UNITED STATES PATENT AND TRADEMARK OFFICE

10/668,445

Office Action Summary	Application No. 10/668,445	Applicant(s) MARINO ET AL.	
	Examiner CHRISTOPHER D. PRONE	Art Unit 3738

DETAILED ACTION

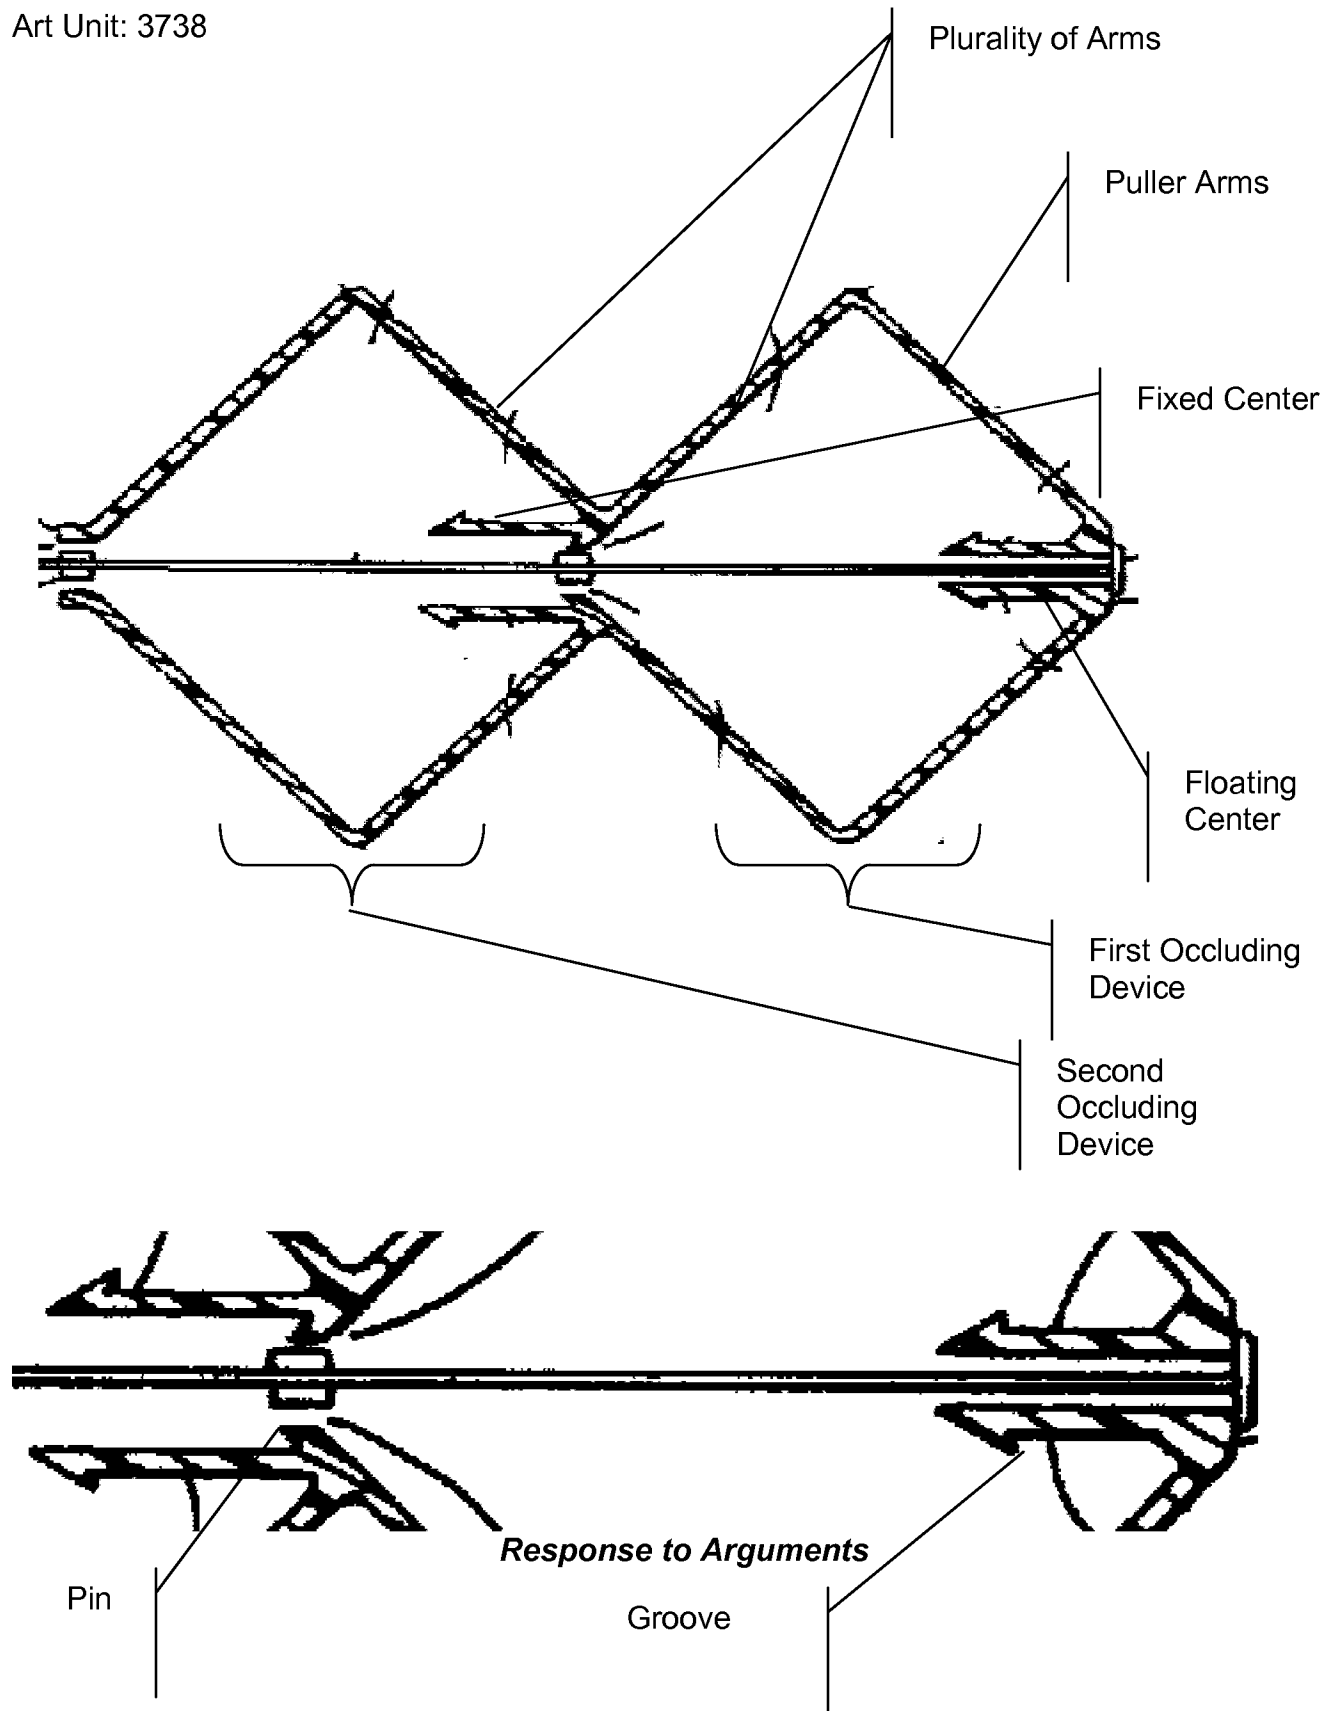
In regards to claims 1, 8, 17, 24, 31, and 38 Huebsch discloses the same invention being an automatic loading mechanism for an occlusion device comprising: a right occluding body (200) comprising a support frame made up of a plurality of arms attached to a fixed center post (242) and puller arms connected to a floating center post (216) having a grasping knob (236), and a left occluding body (comprising a plurality of

arms attached to a fixed center post. Huebsch discloses that first and second support frames (222) comprise elastic shape memory fixation devices described in column 3 on lines 64-67 of Huebsch, right and left sheets described in column 4 on lines 25-26. The floating center is positioned adjacent the fixed center when the body is in the open state (figures 16 and 17). The floating center is movable proximally from the fixed center when in the compressed shape shown in figure 14, wherein when the body is in the compressed state the fixed center can be pulled out or pushed out away from the floating center. (See Figures included below for further explanation)

Applicant's arguments filed 11/19/07 have been fully considered but they are not persuasive. The applicant argues that the arms of Huebsch do not engage the center post at their radially inner most ends. The examiner disagrees with this because the inner most portion of the arms ends at the center post. See above figures for further clarity
